**ADDENDUM NO. 1
to the
Bid Documents
for
DPW Project #24253
UI Nez Perce Drive Improvements
Moscow, Idaho**

January 28, 2026

- Supplemental Information is attached:
 1. IDOPL Approved Plans, full set reissued, see attached.
 2. Grading plans with proposed contours showing, reissued, see attached.
 3. Revised Bid Proposal Form, see attached.
 4. Booster Pump detail CL-01, see attached.
 5. Joe Vandal Photo and Detail for mold development, see attached.

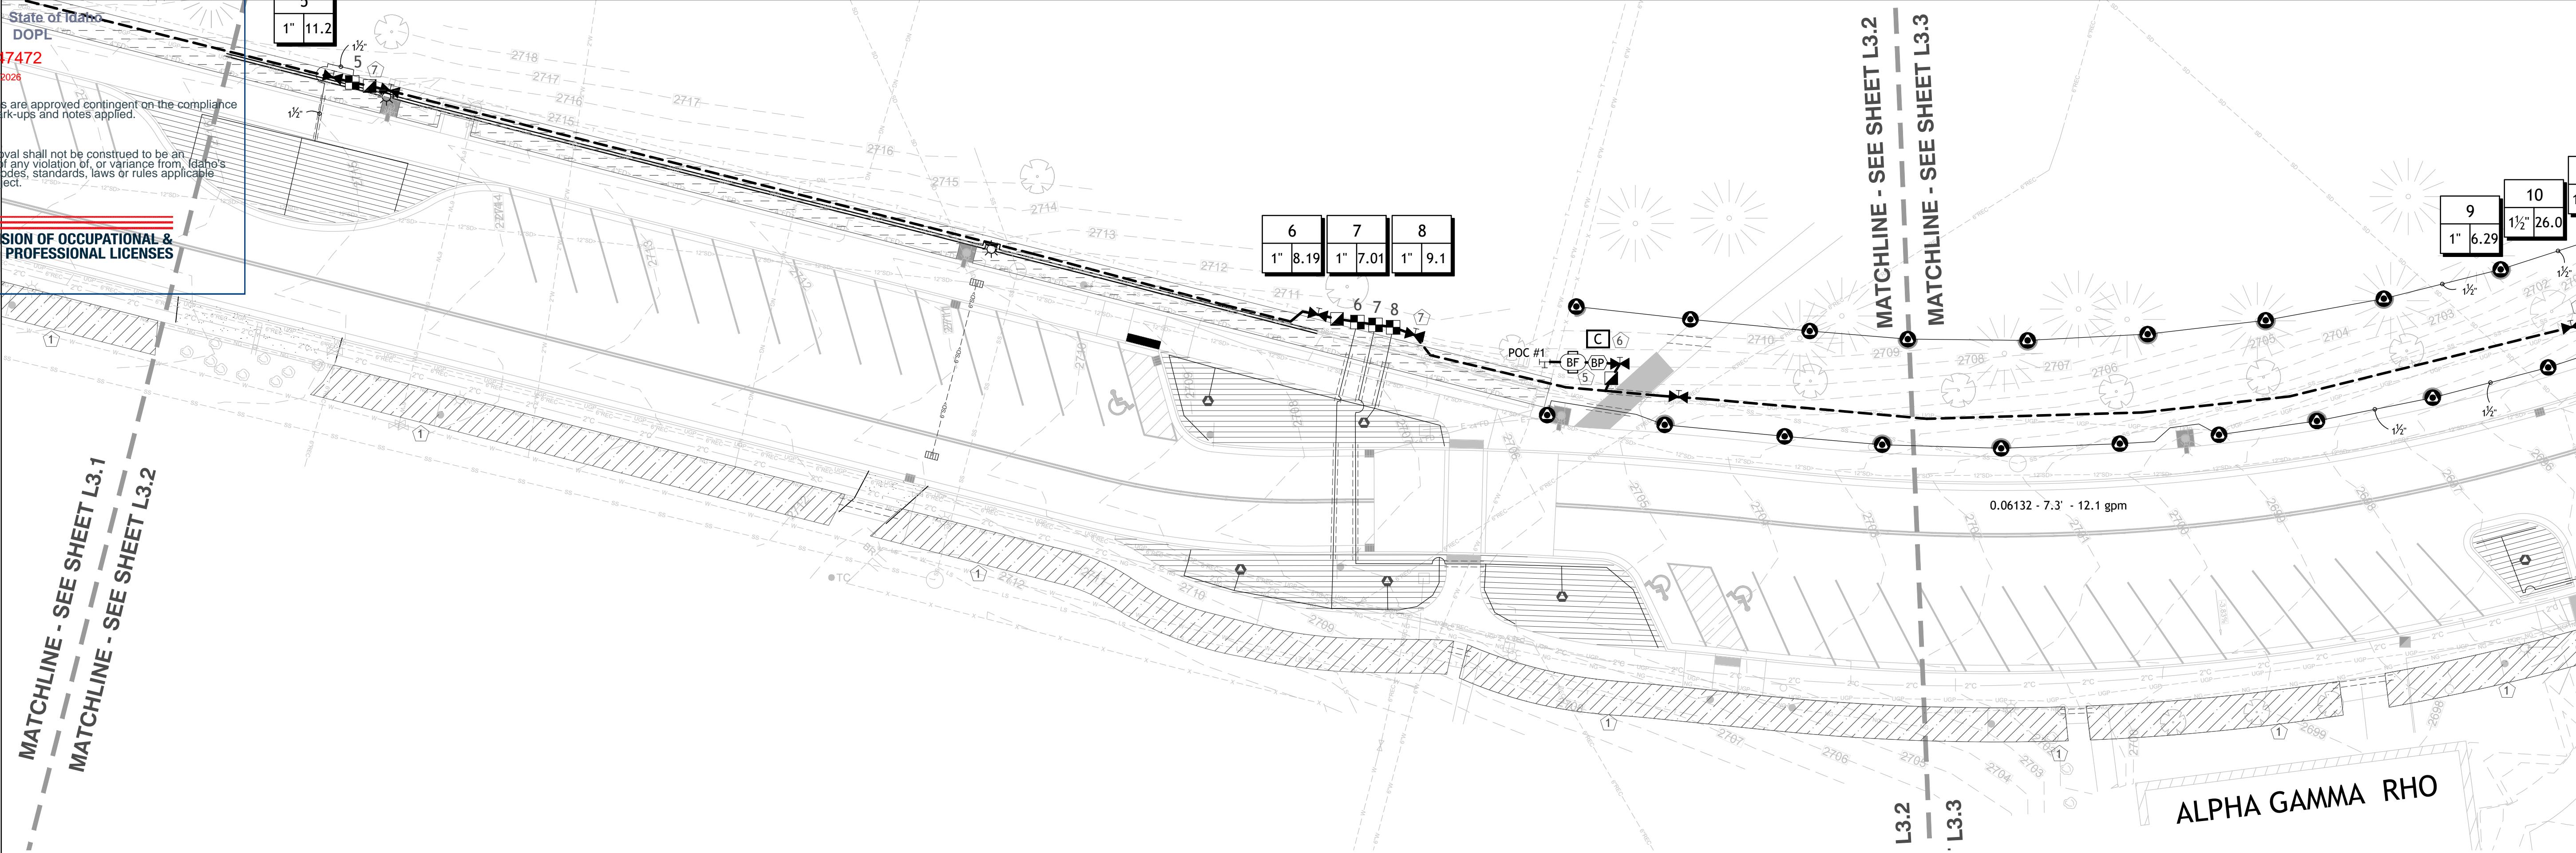
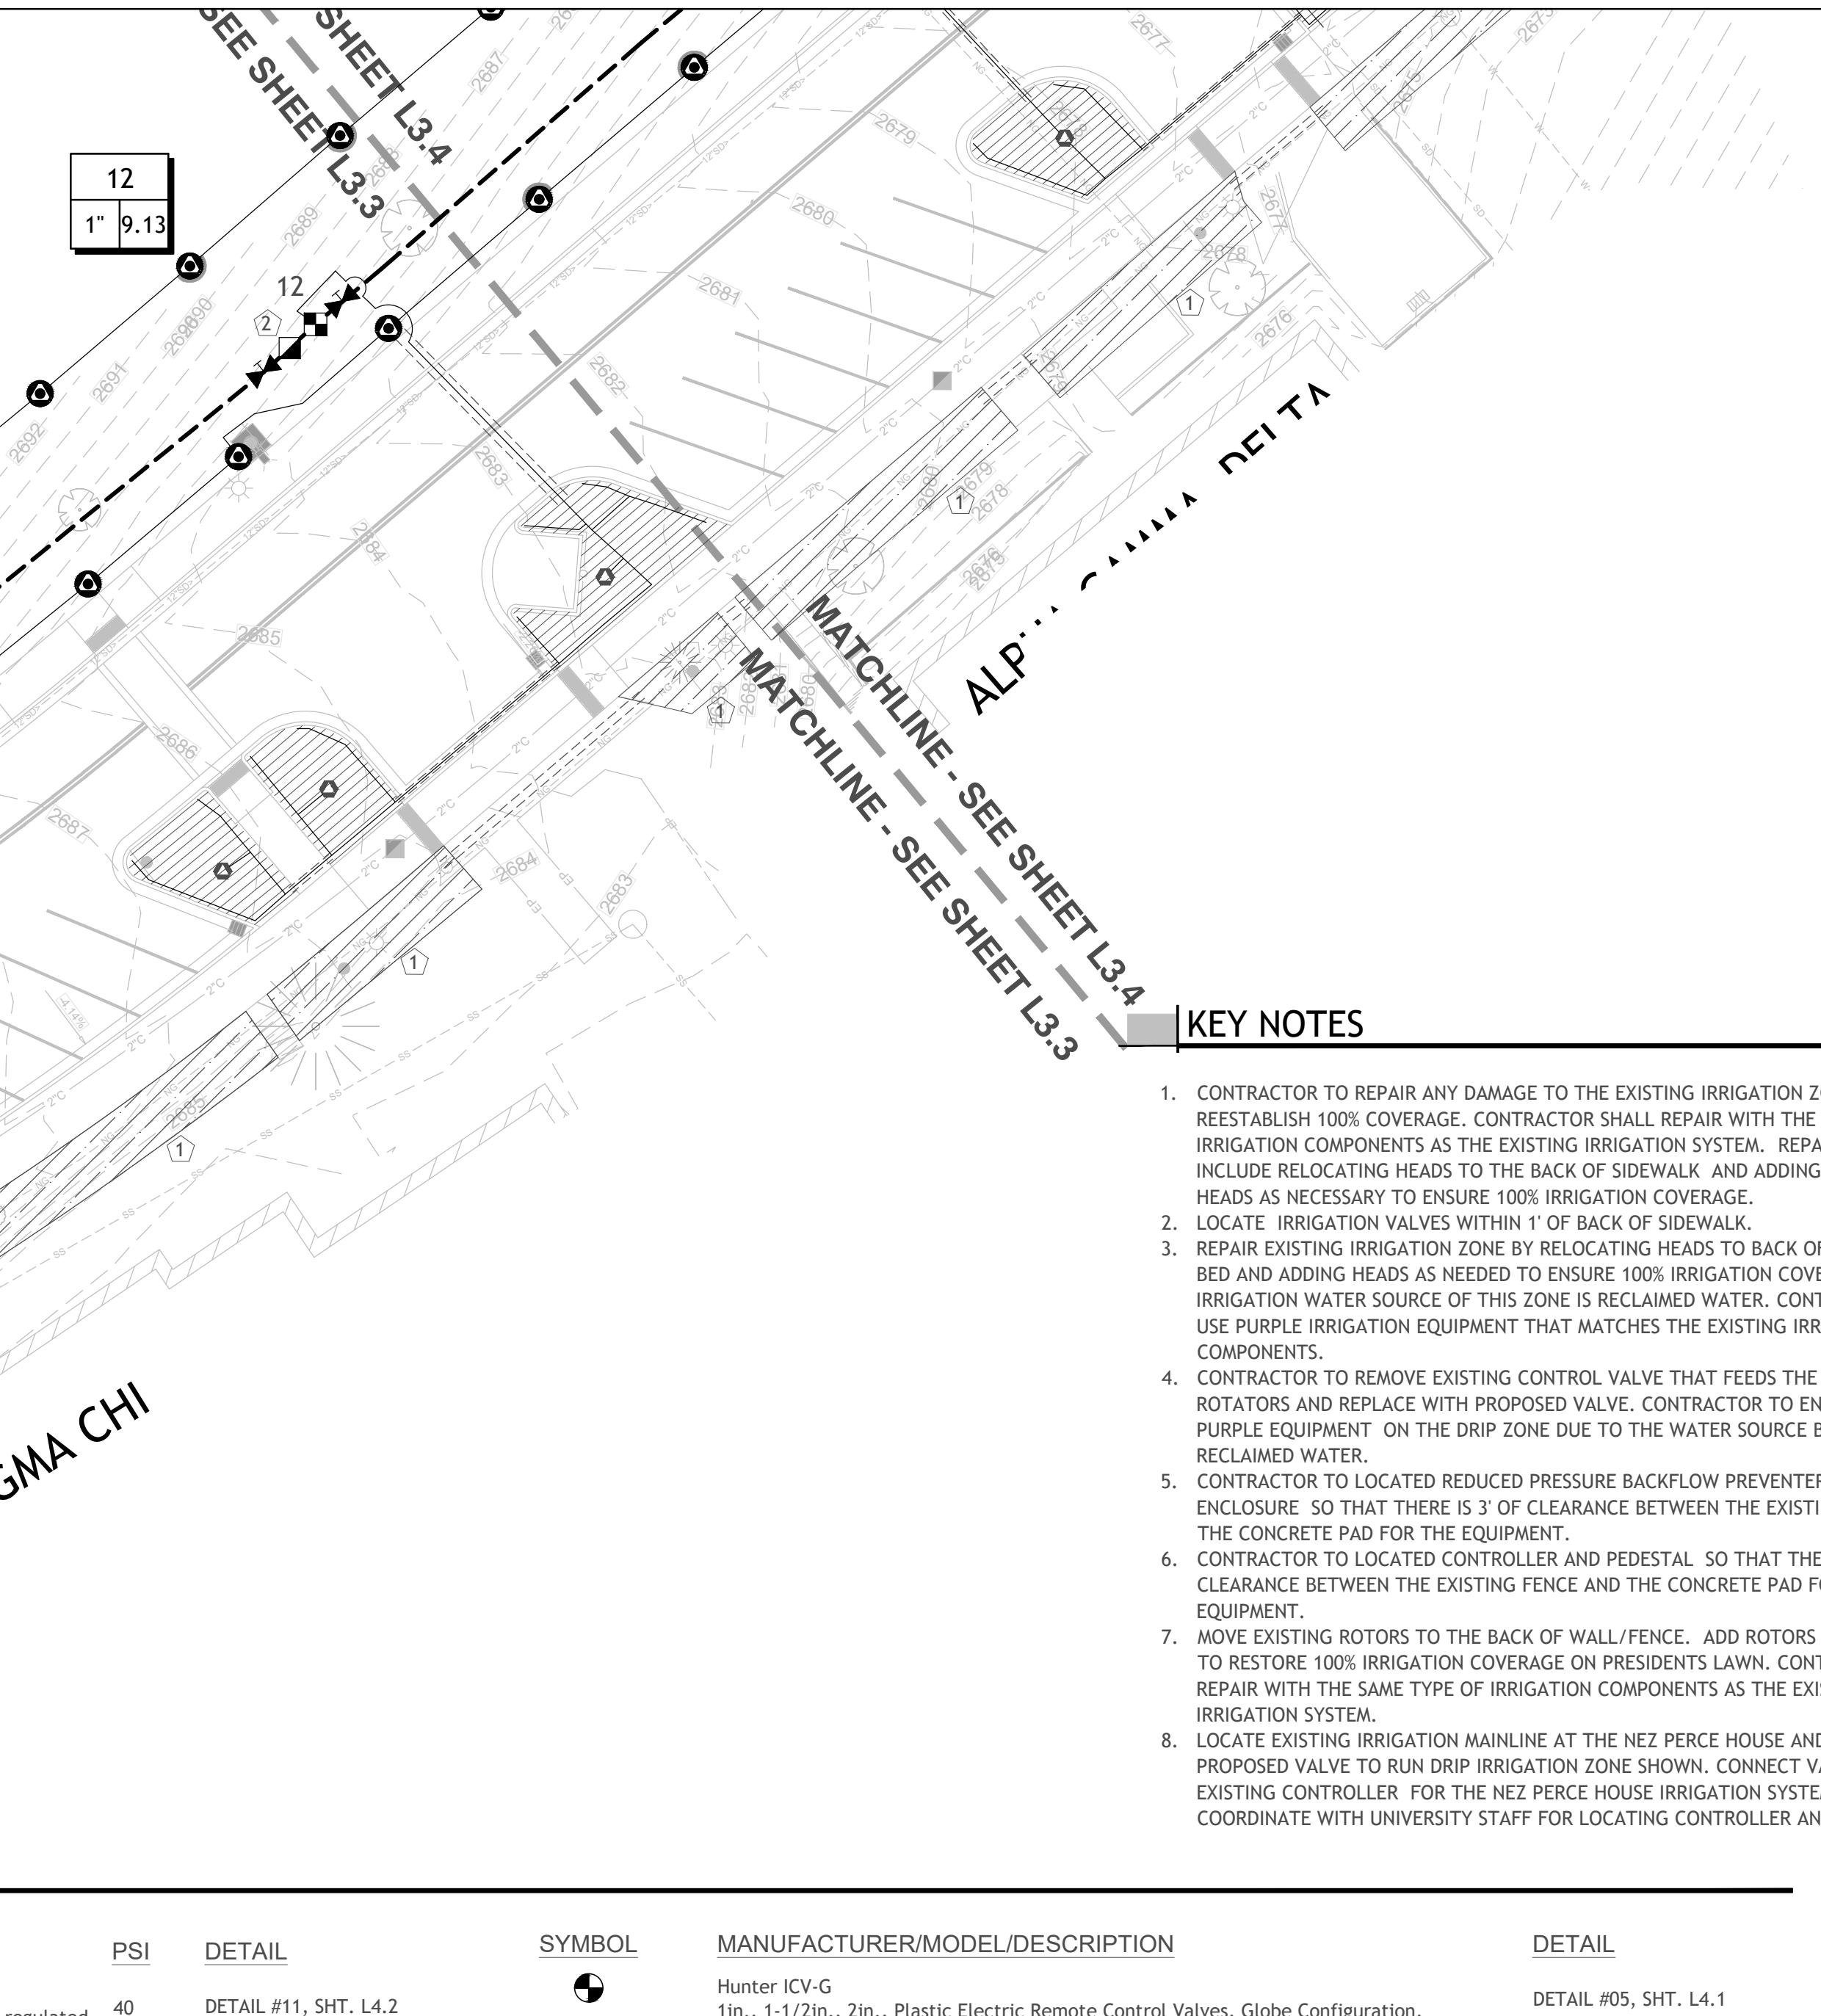
Irrigation Note #28: Revise: Revise note to read “All Irrigation Control Wire shall be 12 Gauge direct burial single conductor PE irrigation Wire. 2 Spare wires shall be installed throughout the entire irrigation system and be of a Unique Color (Orange).
2. REVISION: SHEET L3.0-L3.5

*Irrigation Legend Booster Pump: Revise: Revise to read
“Rainbird Compact Low Profile 3HP VFD Pump Station
3HP. Shall boost pressure 35 psi, up to 50 GPM. Power requirement 208V 60 HZ 3-phase.
Variable Frequency Drive. Pump Station Shall have a pump start relay, compatible with
central control, contain a bypass manifold, and a fault light alarm, intake and outflow shall
have either threaded or flanged connections. Pump station shall be in a marine grade
aluminum enclosure. Enclosure shall have a heater, thermostat, and insulation.”*
